PRODUCT CHANGE NOTIFICATION (PCN)

AMJE0909-0150-RDB-24
MODULAR CABLE

CHANGE NOTIFICATION: PCN 20220509_AMJE0909-0150-RDB-24

DESCRIPTION OF CHANGES:
CHANGE OF DATA SHEET
CHANGE OF DATA SHEET
New Draw.-No. ASS_7945_CArev02

AMJE0909-0150-RDB-24 OLD VERSION

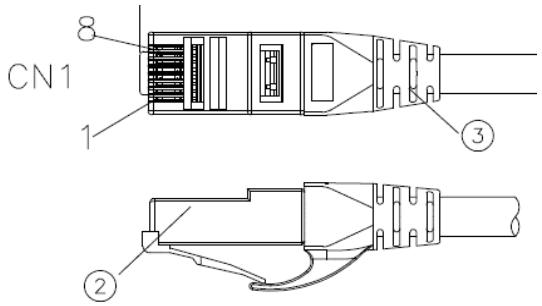
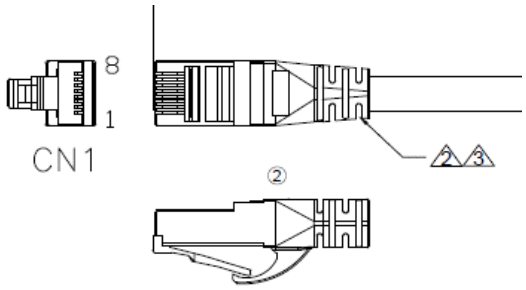
③	Molding	PVC 45P Color: see order code	NA	KG
②	CONNECTOR	RJ45 8P8C two fork Short type 3u" gold plated	2	PCS
①	CABLE	CAT6 UTP (24AWG*1PR)*4+PVC OD=5.8±0.3MM Color: see order code	NA	MM
NO:	NAME	DESCRIPTION	Q'TY	UNIT

3	Molding	PVC 65P Color: see order code ②	NA	KG
2	CONNECTOR	RJ45 8P8C PLUG 3u" gold plated ②	2	PCS
1	CABLE	CAT6 U/UTP (24AWG*1PR)*4+Cross+PVC Jacket OD=5.8± 0.3MM Color: see order code ②	NA	MM
NO:	NAME	DESCRIPTION	Q'TY	UNIT

Drawing-No.
ASS 7945 CA

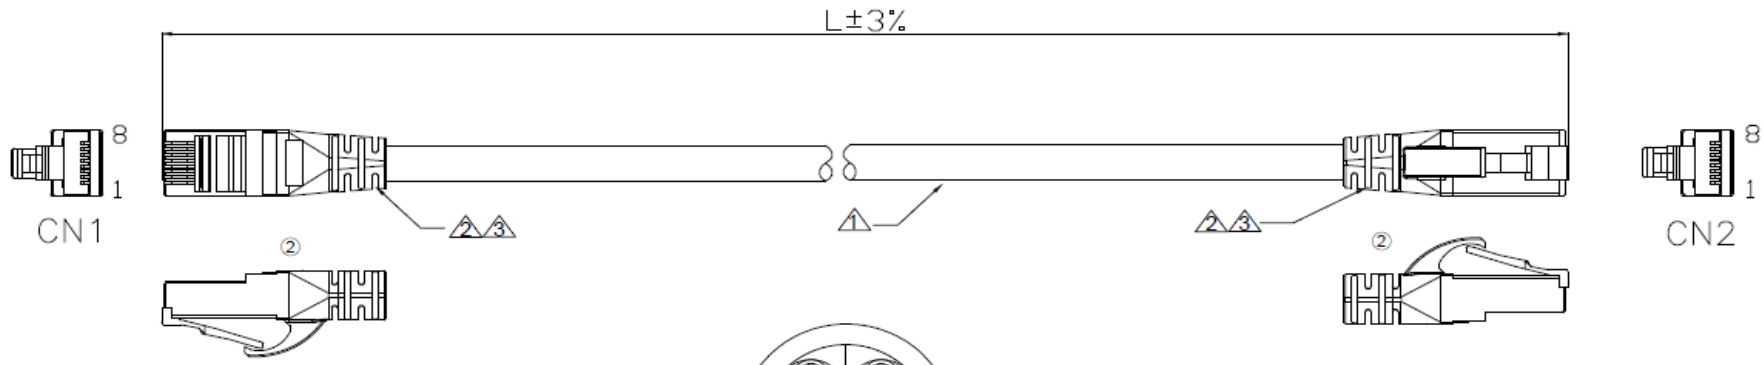
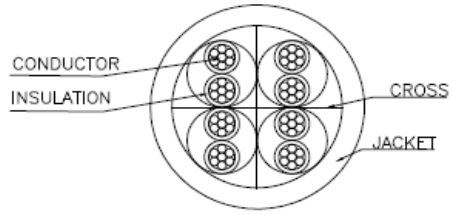
Id.	Modification	Date	Name
②	Change the plant	09.05.2022	Luca
①	Update the WSW order code	02.06.2017	Amy
⓪	Drawn	30.03.2017	Amy

NO:	NAME	DESCRIPTION	Q'TY	UNIT
3	Molding	PVC 65P Color: see order code ②	NA	KG
2	CONNECTOR	RJ45 8P8C PLUG 3u" gold plated ②	2	PCS
1	CABLE	CAT6 U/UTP (24AWG*1PR)*4+Cross+PVC Jacket OD=5.8± 0.3MM Color: see order code ②	NA	MM
